CHANGE ORDER NO. 14

PROJECT:	<u>Horizon City Municipal Facilities Phase I</u>	DATE OF ISSUANCE:	January 27, 2026
OWNER:	TOWN OF HORIZON CITY 14999 Darrington Rd. Horizon City, Texas 79928	EFFECTIVE DATE:	January 27, 2026
CONTRACTOR:	<u>Dantex General Contractors</u> <u>4727 Osborne</u> El Paso, TX 79922	ARCHITECT:	Eugenio Mesta, AIA Exigo Architects 211 N. Florence Ste. A El Paso, Tx 79912
CONTRACT FOR:	<i>New Municipal Facilities for the City of Horizon</i>	OWNER'S BID NO.	CSP 23-038 Project No. 2.513D
		ARCHITECT'S PROJECT NO:	20201600

TITLE: Additional Power and Data Drops per ASI #07

To: DANTEX Construction
From: Jesus Ortega, EXIGO Architects
Project: HCMF
Date: November 13, 2025
Re: **ASI 007 – New Power and Data request**

SPECIAL SYSTEMS PLAN 'B'

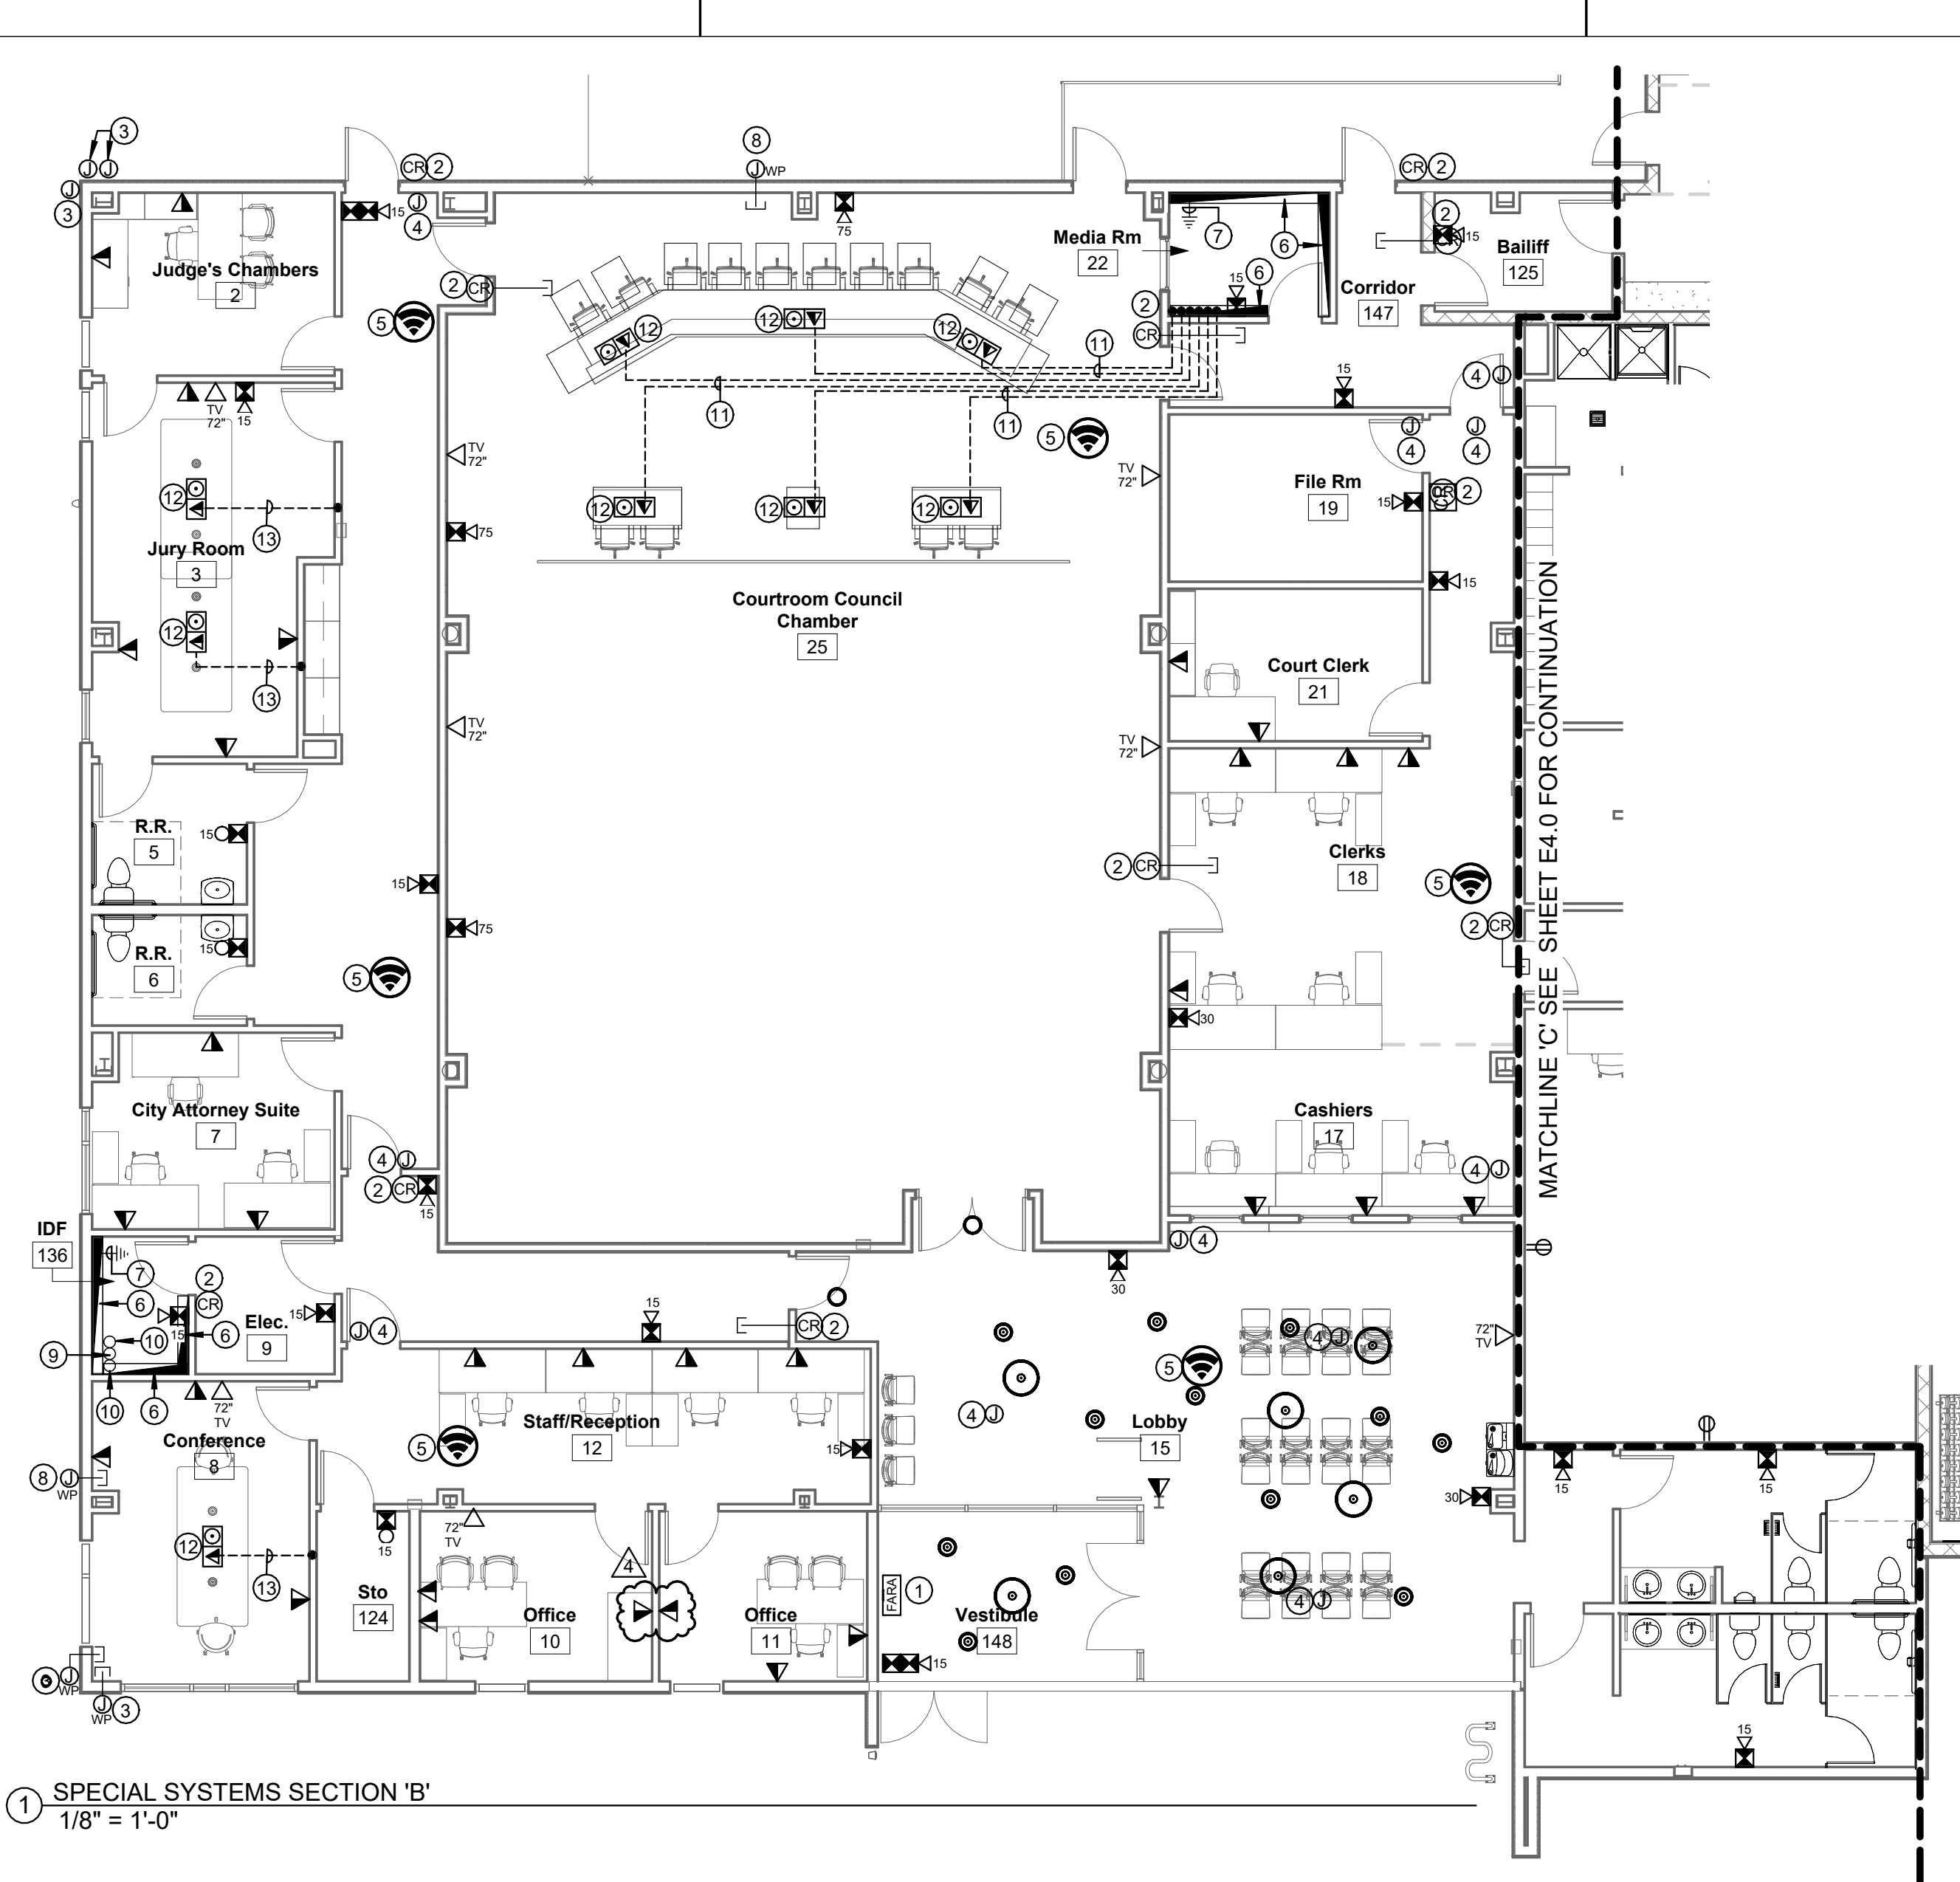
- a) ASI 007 – E3.0R2 – Delta#4: Power Plan “A”_
- b) ASI 007 – E4.0R3 – Delta#4: Special Systems “A”
- c) ASI 007 – E4.1R1 – Delta#4: Special Systems Plan “B”
- d) ASI 007 – E6.0R2 – Delta#4: Panel Schedules
- e) ASI 007 – E6.1R1 – Delta#4: Panel Schedules
